Re: Request for Appeal of Notice of Violation from the City of Indianapolis Department of Business and Neighborhood Services – Simon Tower Starbucks

Simon Tower - Starbucks Tenant
10 S Capitol Ave
Appeal of Local Order - IC 22-12-7-12

This letter is a request for Appeal of the enclosed Notice of Violation issued for the above referenced project from the City of Indianapolis, Department of Business and Neighborhood Services, dated August 3, 2018, regarding electrical outlets above show windows.

Violation: 2009 Indiana Electrical Code 210.62 Show Windows
Show windows require electrical outlets.

1 STOREFRONT INTERIOR ELEVATION
Scale: 3/8" = 1'-0"

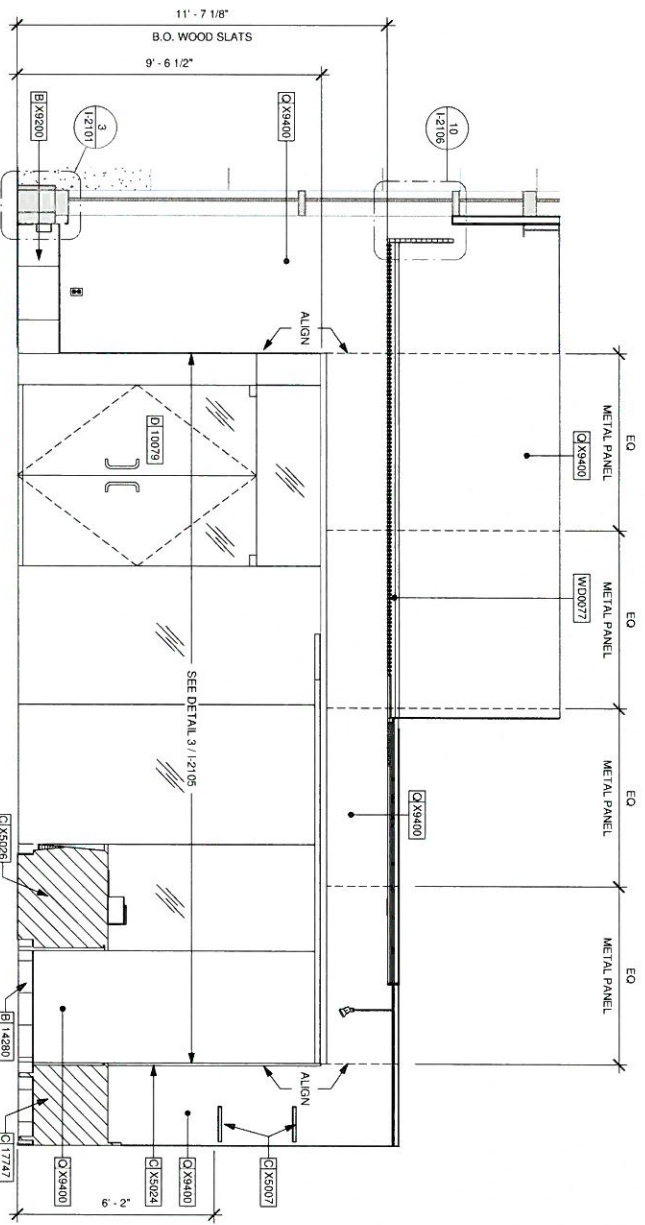
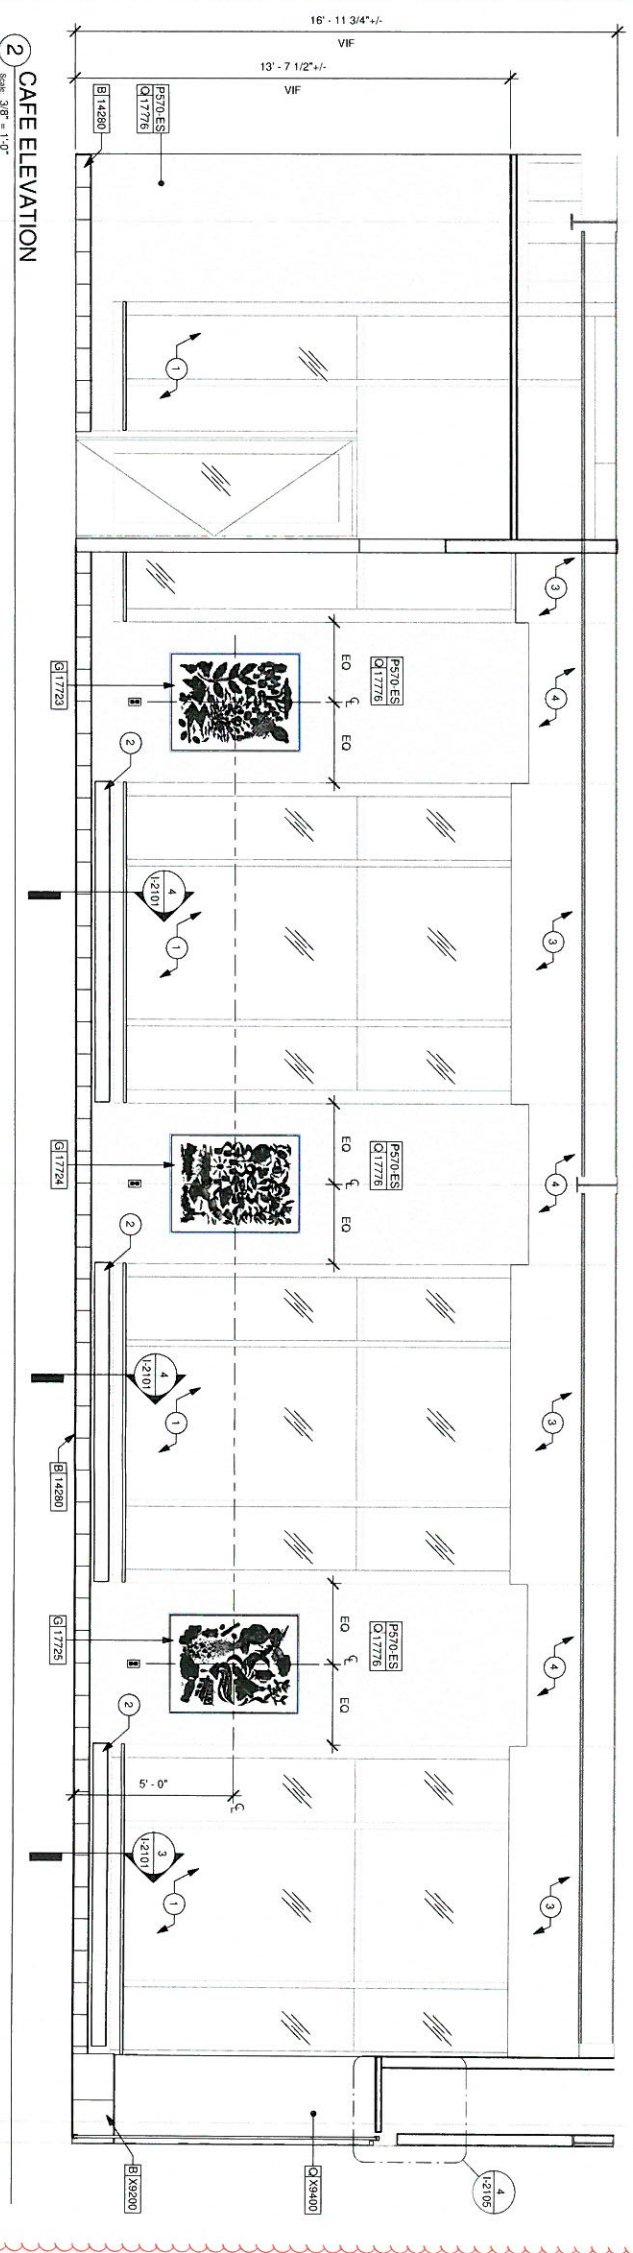
The design team, on behalf of the owner, has been working with RTM to investigate and resolve the issue. We believe the windows in question do not meet the definition of “show windows” and are therefore exempt from the requirement to provide electrical outlets above the windows. The windows were not designed to be used for display of goods or advertising material. We believe the intent of this code section is to provide outlets for lighted signs or displays of goods, neither of which are proposed at the windows in question. The windows are along a seating area without any displays, and will have only non-lighted signage. Please see enclosed Exhibits A through D for a copy of the floor plan and interior elevation that were included in permit submittal showing the windows in question, photographs of the windows as built, excerpts from the 2008 National Electrical Code Handbook that was used for guidance in our interpretation, and emails from the State Building Commissioner confirming our interpretation is a common interpretation of this code.

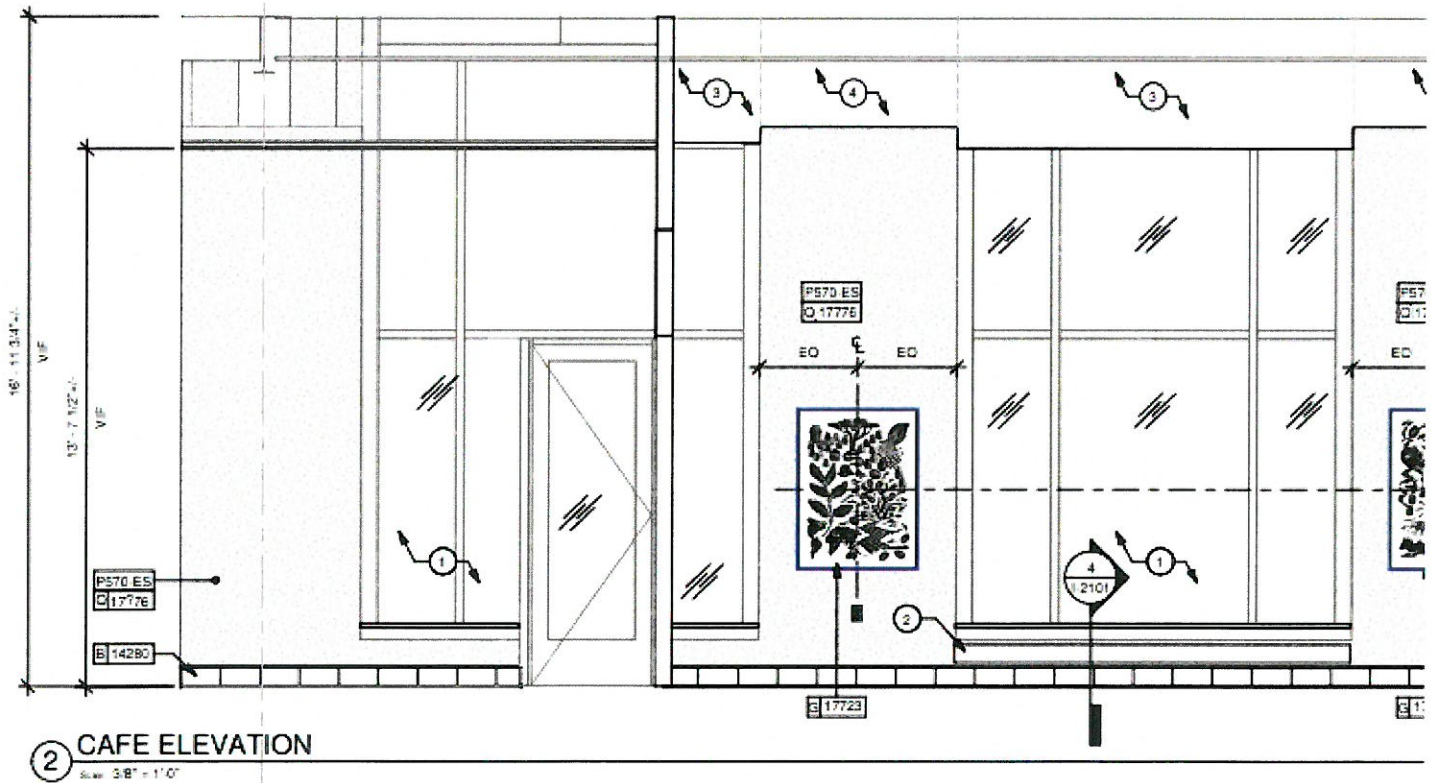
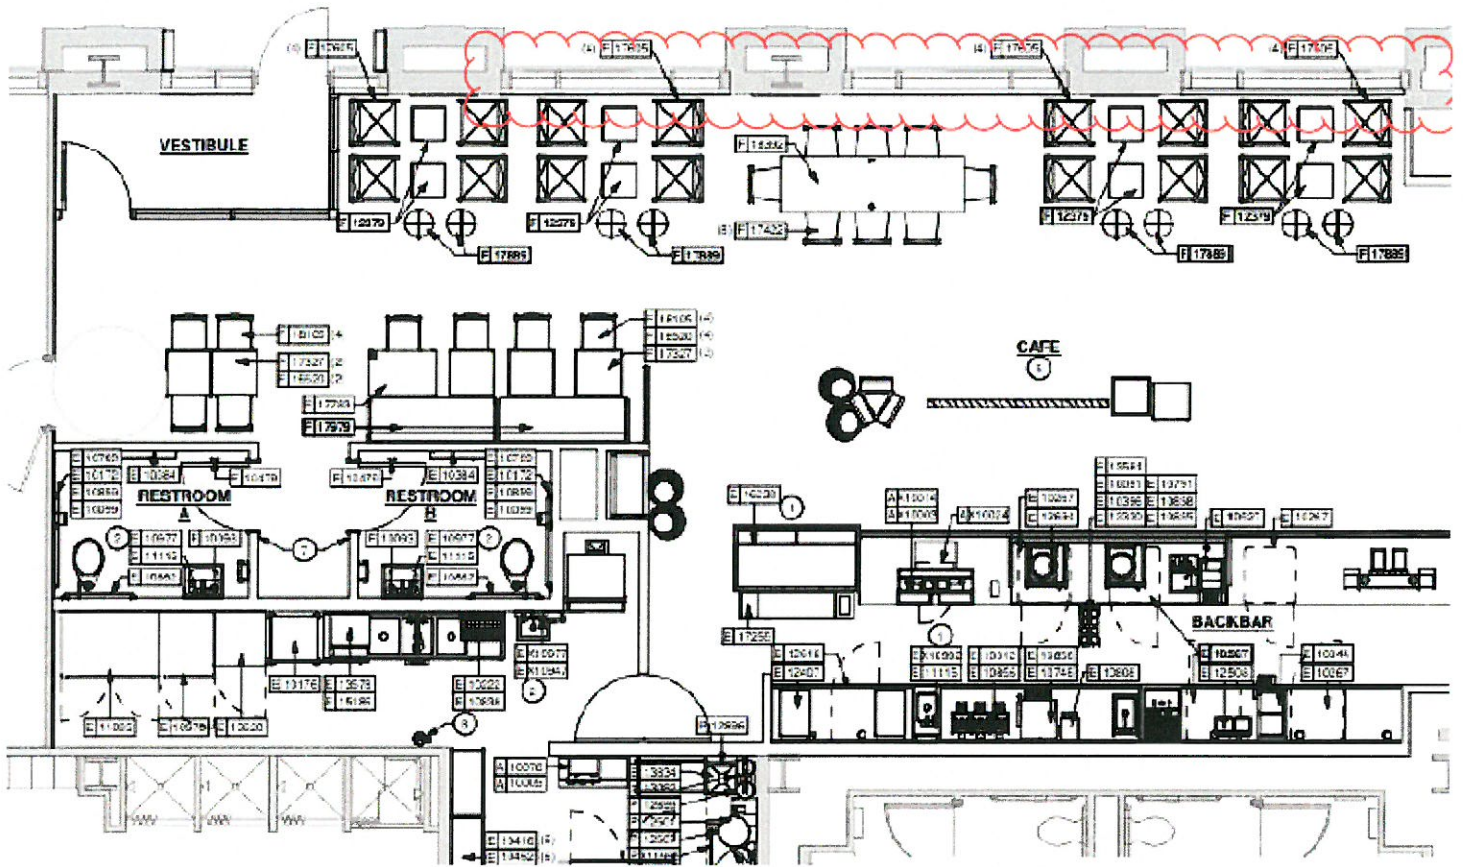
We have a client working on a downtown tower, 1st floor tenant space with storefront windows. The tenant is a coffee shop with seating along the windows. A question came up with the inspector wanting to apply the requirement in NEC 210.62 for "show windows" to have outlets above the windows (see below code section and definition). I don't think it is the intent for the windows in this case to be "show windows." When I think show windows, I think of retail spaces where displays are created to draw people into the store. The windows of a coffee shop along a seating area are just windows. They will not be displaying goods or advertising materials in these windows, they are just tall windows along the seating area. It is my interpretation that they do not have to add outlets per NEC 210.62. Would you agree? If not, then we have a lot of windows out of compliance all over the City.

Below are the furniture layout and interior elevation plans that were submitted under the permit. I don't see any indications of proposed use as show windows. The inspector has also suggested that even if this tenant doesn't plan to use them as show windows, a future tenant might and so they need to provide the outlets. I am suggesting they are not required to plan for future tenants, but if a future tenant decides they want to provide show windows in this space, then at that time they would have to comply with the requirements for show windows. (Though I think it is highly unlikely that with this particular layout and location that these will ever be actual show windows – displays would take up too much floor space.) We can't plan for all possible uses in the future, we have to apply the code to the current use. Would you also agree that we need only apply codes applicable to the currently proposed use?

The NEC actually defines "show window," and according to them it's a window "used or designed to be used for the display of goods or advertising material." If all they're doing is putting tables and chairs in the windows, I don't believe that would constitute the display of goods or advertising materials.

Since I don't believe the intent of the code is to provide power to non-powered signs, bills and all the other paper ad media you often see in shop windows, the bottom line for me is this: if they never plan to put advertising materials that require power in those windows, and they never plan to use any part of the windows to place any kind of product display, then they aren't "show windows" and aren't subject to 210.62. If they do plan to do any of those things, they're show windows and have to comply.
